RS-15-129

Braidwood Station, Units 1 and 2
Facility Operating License Nos. NPF-72 and NPF-77
NRC Docket Nos. 50-373 and 50-374

Subject: Response to Request for Additional Information Regarding Request for a License Amendment to Braidwood Station, Units 1 and 2, Technical Specification 3.7.9, "Ultimate Heat Sink"

Response to Request for Additional Information

RATIO OF EFFECTIVE TO CROSS AREA FOR LAKES OF VARIOUS LENGTH TO WIDTH AND DEPTH TO WIDTH RATIOS
Figure MES-11.1-02

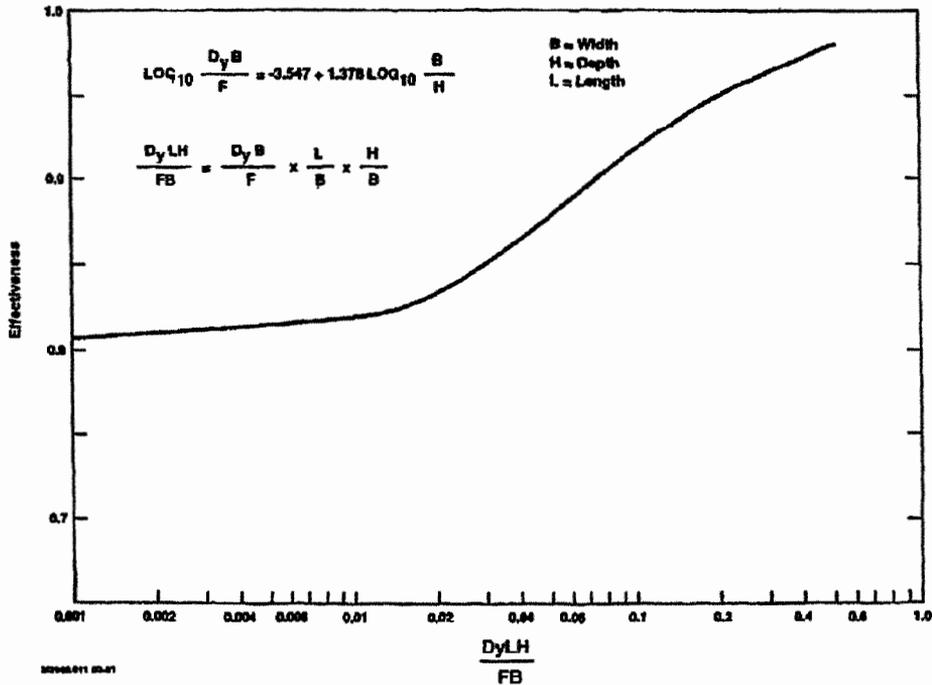
Provide justification that demonstrates that the LakeT-PC model accurately represents the effective essential cooling pond volume and surface area with sufficient accuracy and within the margin of error for the temperature of cooling water that supplies the safety related loads.

Effectiveness - Effective Area and Volume were calculated to be 82.3% of gross values. Effectiveness of the UHS was determined in Calculation MAD 83-0239. The methodology utilized for calculation of the Braidwood UHS effectiveness has subsequently been documented in S&L Engineering Guideline MES-11.1. The main inputs for lake effectiveness are the lake

size/shape and water flow. Based on figure MES-11.1-02, presented below and as included in a response to an NRC RAI received for the LaSalle UHS temperature increase request (Reference 9), the effectiveness of the main channel varies from approximately 81 to 98%. Therefore, the value of 82.3% calculated in MAD 83-0239 is conservatively on the lower side of the curve. Note that the Braidwood UHS is a man-made rectangular shape lake without any side arms or odd shapes.
